**FINAL**  
**ENVIRONMENTAL IMPACT REPORT**

**LION'S GATE RESERVE**

**Lead Agency: County of Santa Clara**

**File #4039-67-28-93**  
**SCH #94043016**

FIGURE 9a (REVISED)

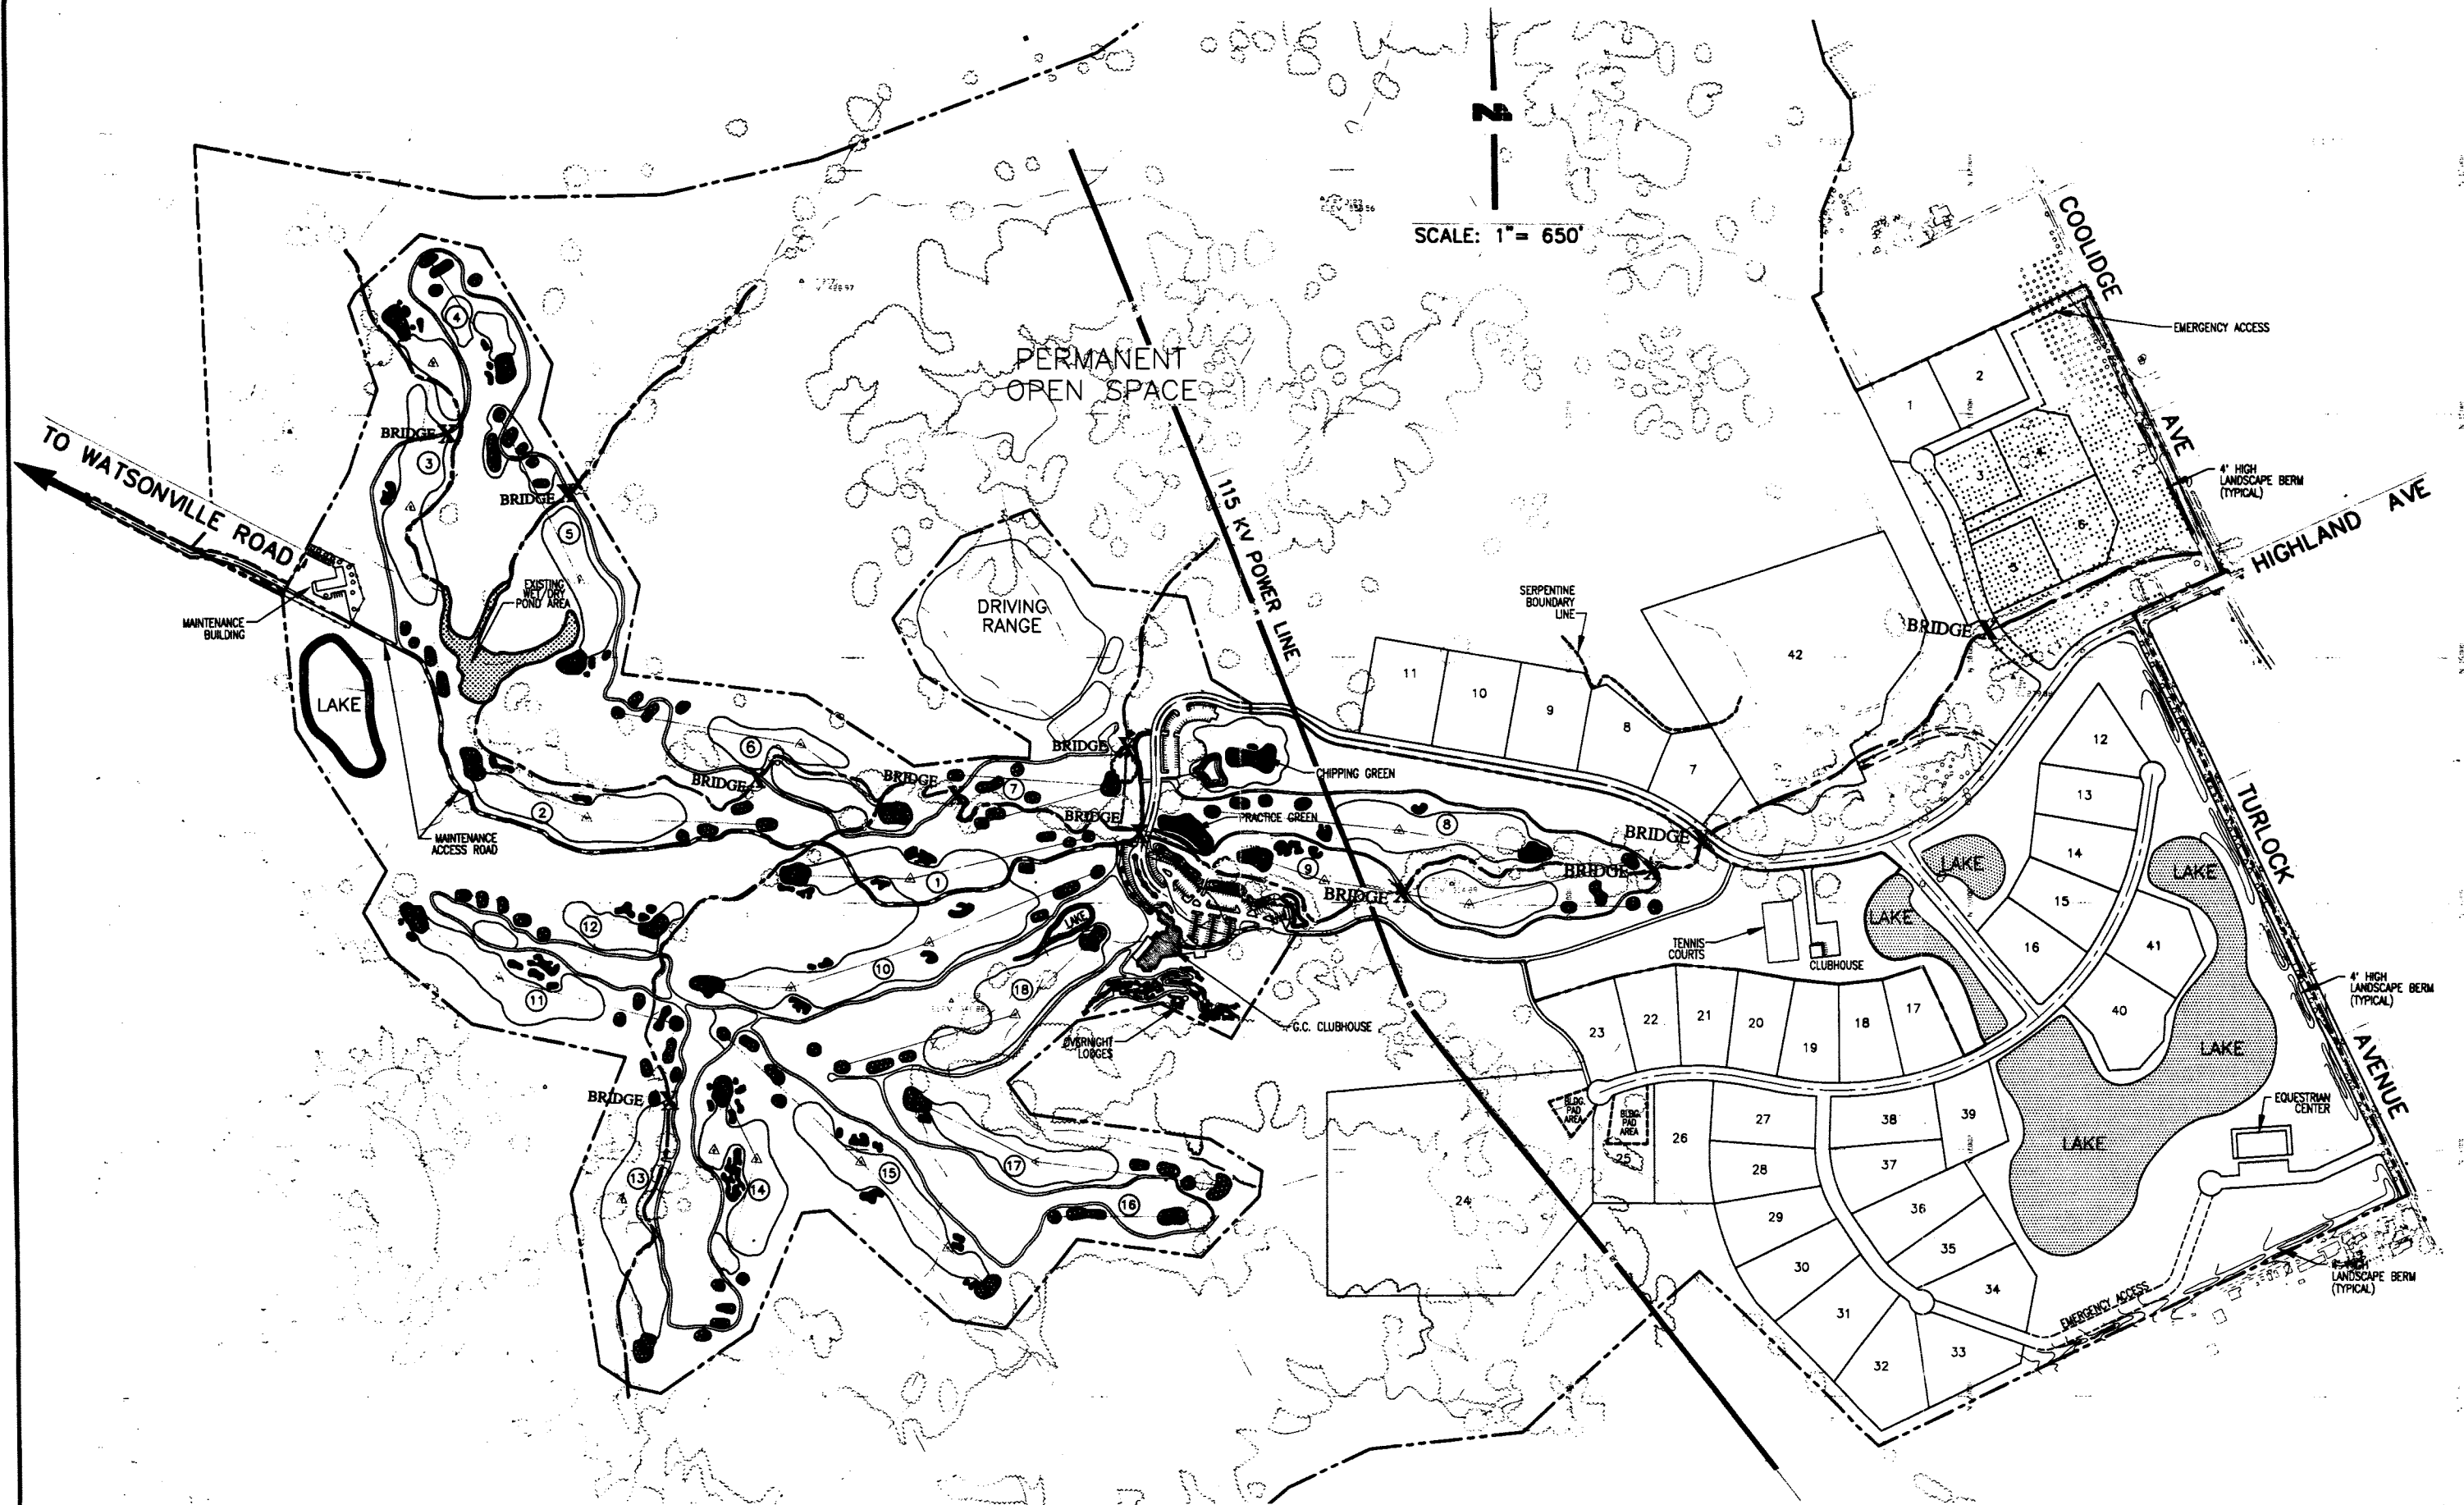
p.14 Replace "Figure 9a" with "Figure 9a (Revised)" on the next page.

**PROJECT SITE PLAN**  
**FIGURE 9b (REVISED)**

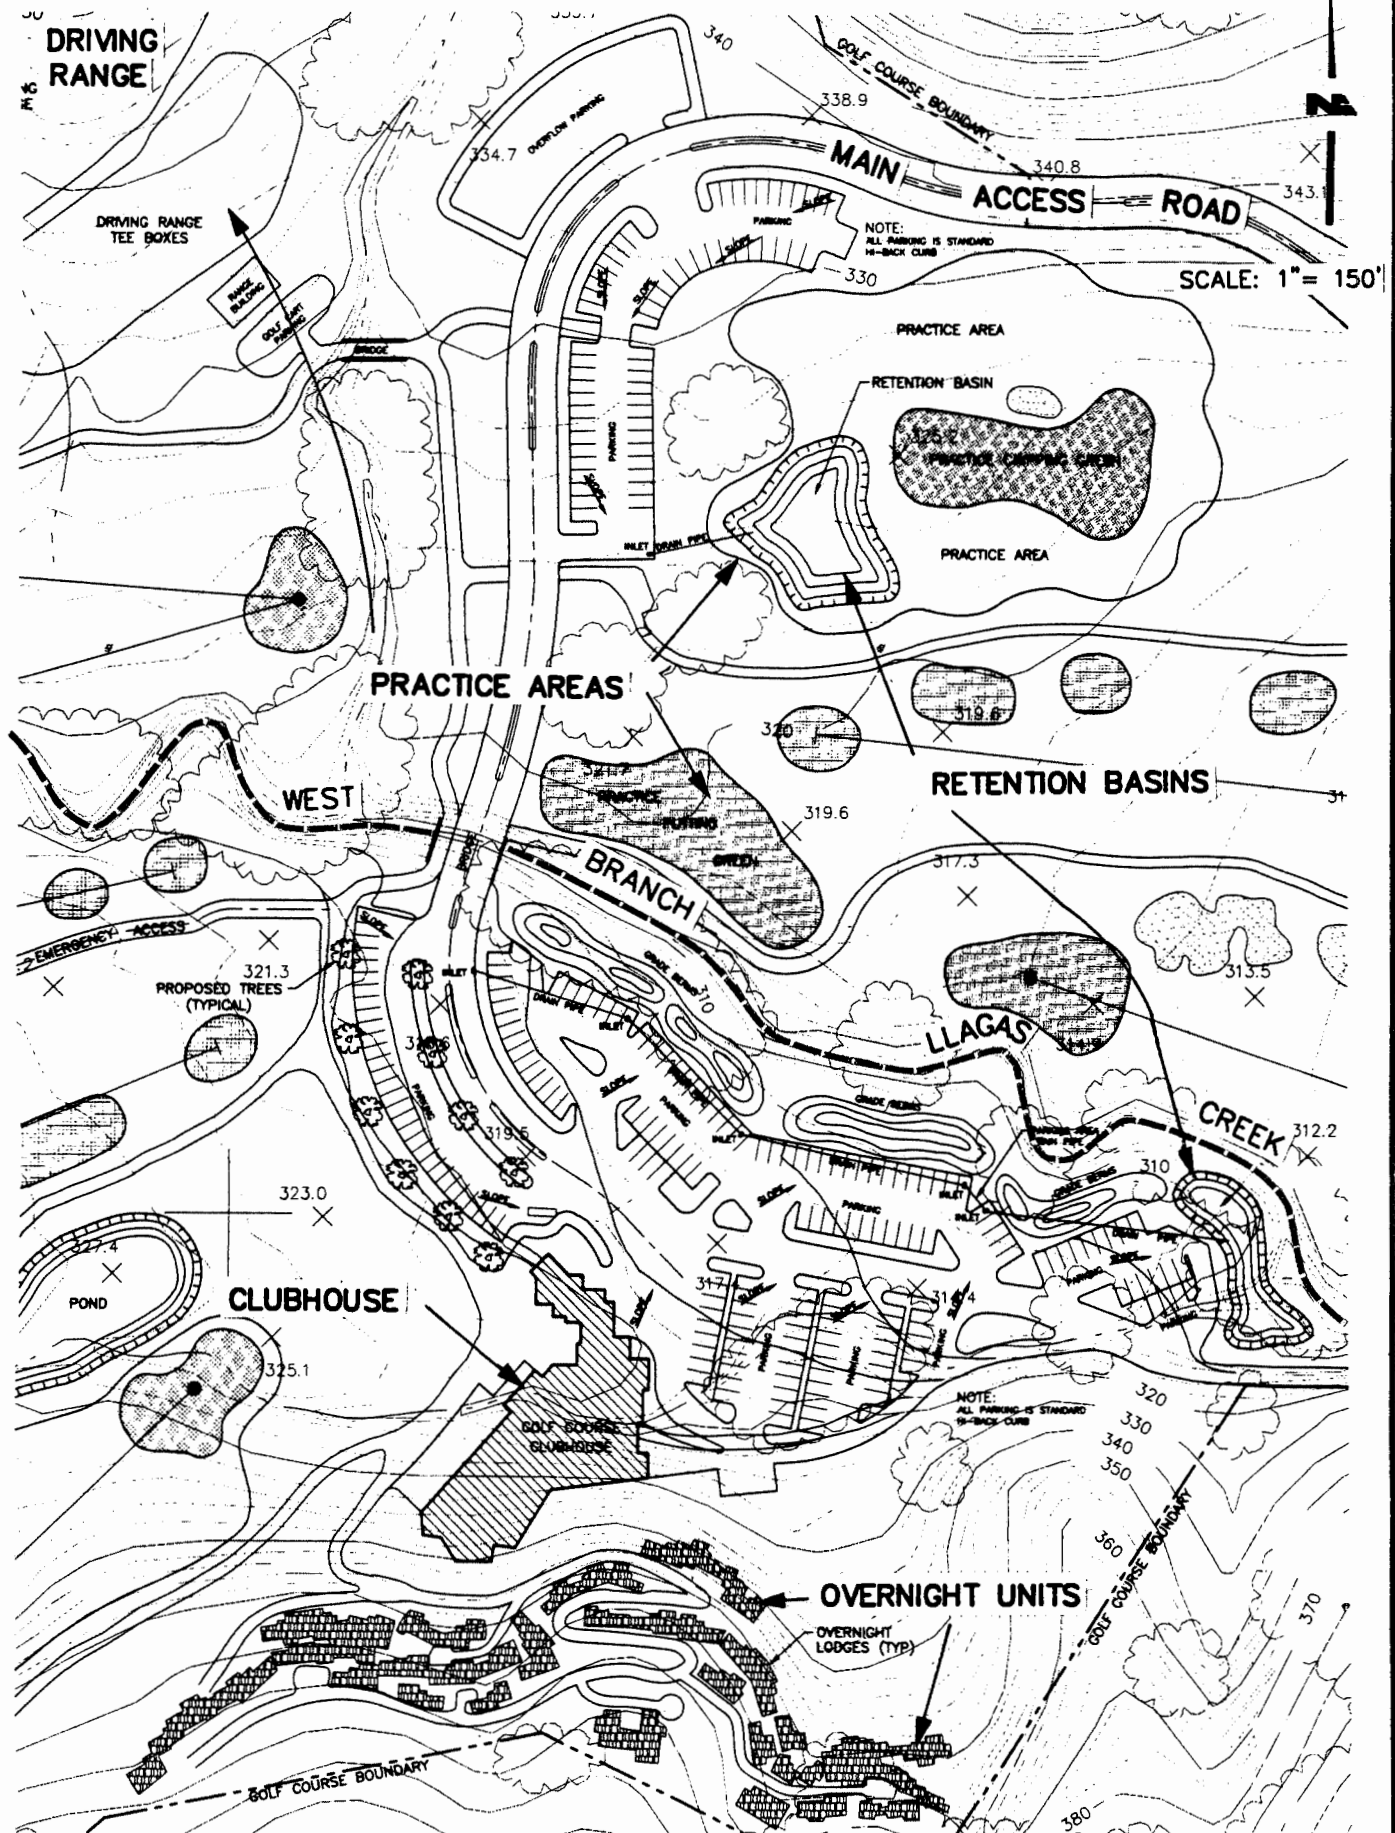
41. Subsequent to the release of the DEIR, the applicant revised the golf course plan to eliminate 5 golf cart bridges, leaving 8 cart bridges and 2 roadway crossings. (See revised Figures 9b and 10a in Section V. *TEXT AMENDMENTS*.) These proposed crossings were sited to avoid existing riparian woodland. Bridges would all span the creek channel to allow for wildlife movement underneath. Since the crossings would all occur in areas where the existing habitat is degraded, the impacts would be minimized.

30. Upon further review of the golf course plan, the applicant has identified 5 crossing points that can be eliminated or combined with nearby bridge crossings. These refinements are reflected in the revised Figures 9b and 10a. (See Section V. *TEXT AMENDMENTS*.)

33. The crossings in the central area of the golf course can be clearly identified in Figure 10a (as revised). Figure 9b has also been revised to more clearly indicate the bridge crossings. Figure 15, the Riparian Habitat Restoration and Enhancement Concept, has been revised to highlight the turfed areas, so that the buffer zones along the creek can be more readily discerned. (See Section V. *TEXT AMENDMENTS*.)

p.15 Replace "Figure 9b" with "Figure 9b (Revised)" on the second next page.

FIGURE 10c

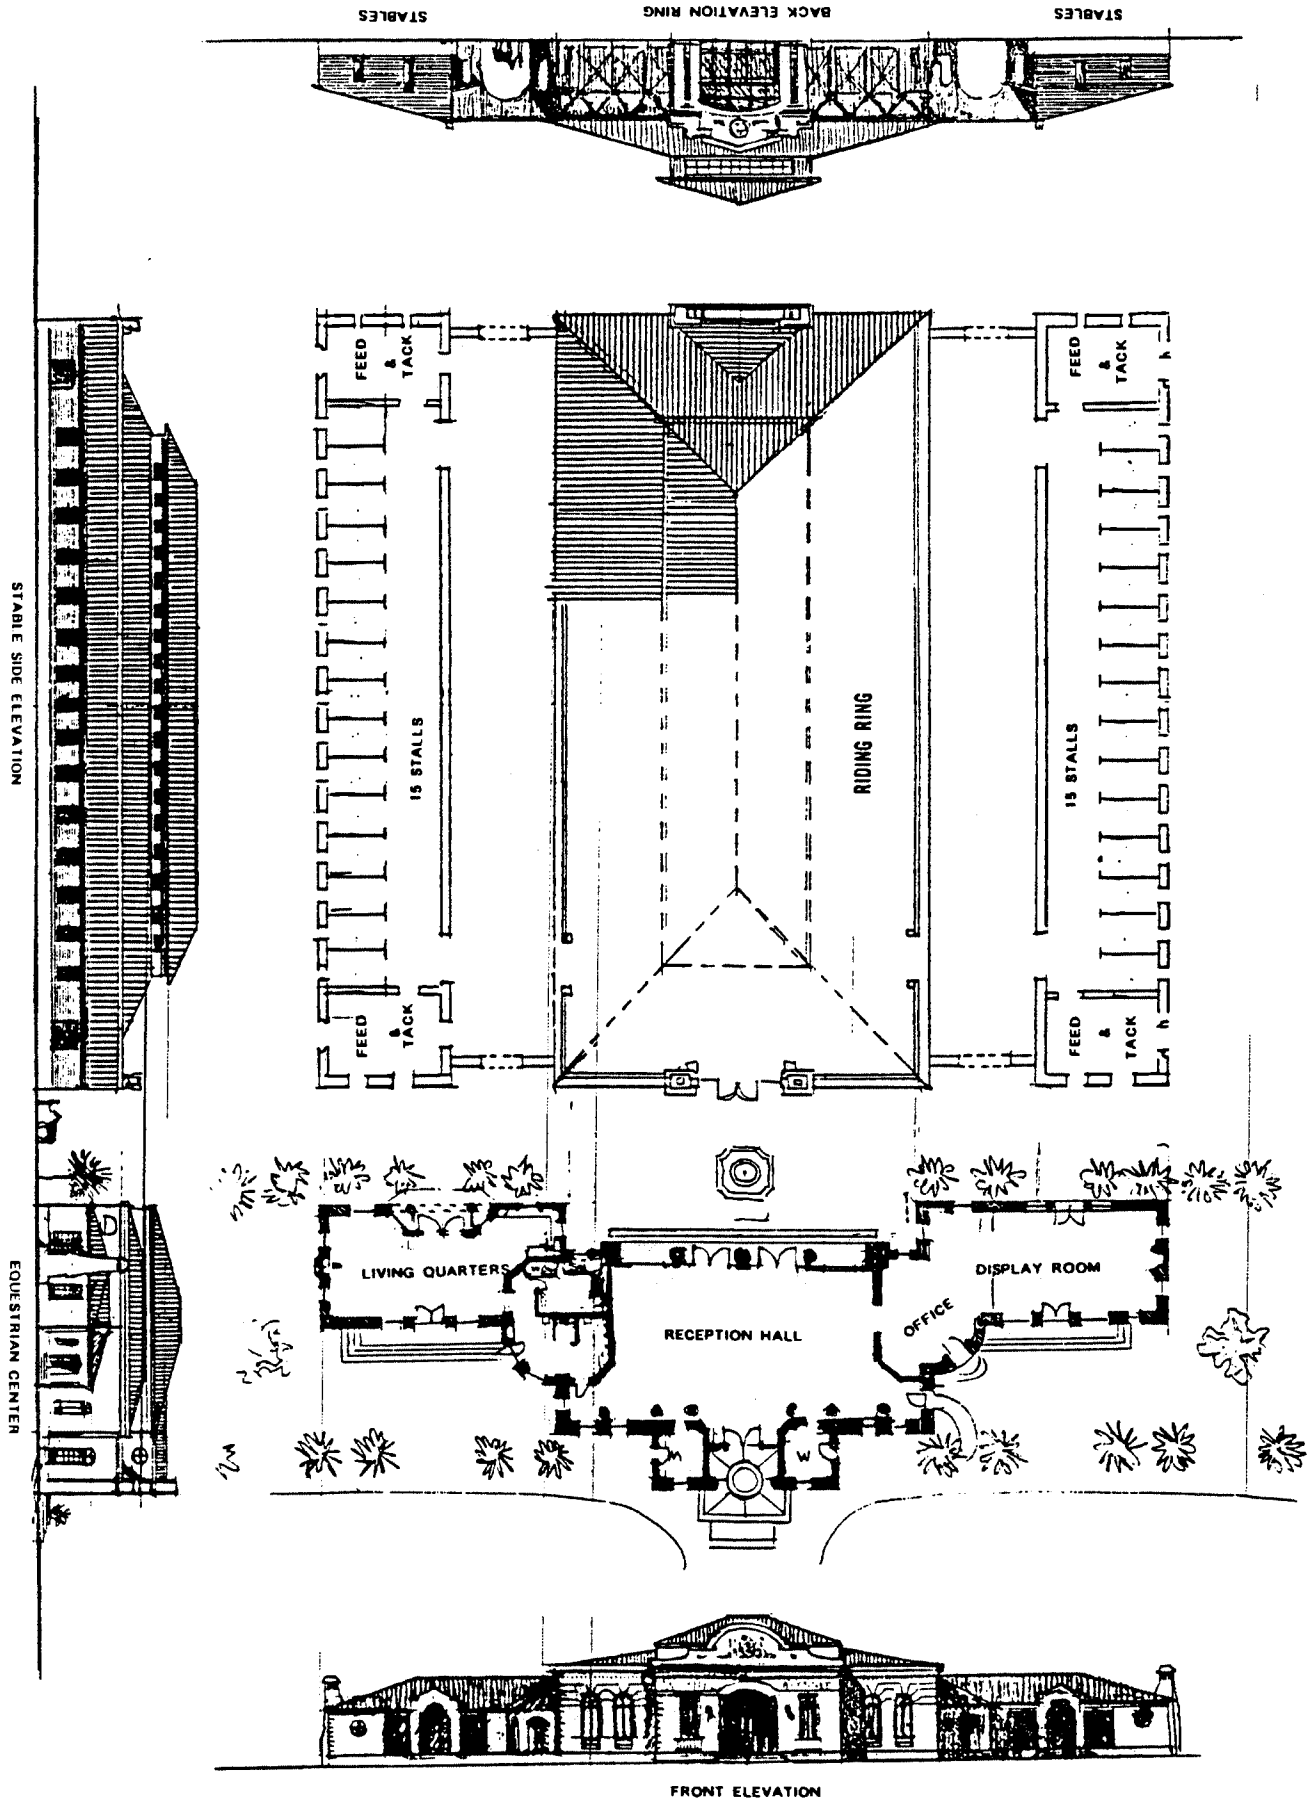
15. The equestrian center would comprise an enclosed riding area (20,000 square feet), stables (12,000 square feet), caretaker's quarters (1,800 square feet), reception hall (5,000 square feet), and office and display room (3,200 square feet), for a total of 42,000 square feet. A new figure showing the floor plan and building elevations of the equestrian center has been added to the EIR as Figure 10c. (See Section V. *TEXT AMENDMENTS*.)

- p.24 Insert the new Figure 10c after page 24, as shown on the following page.
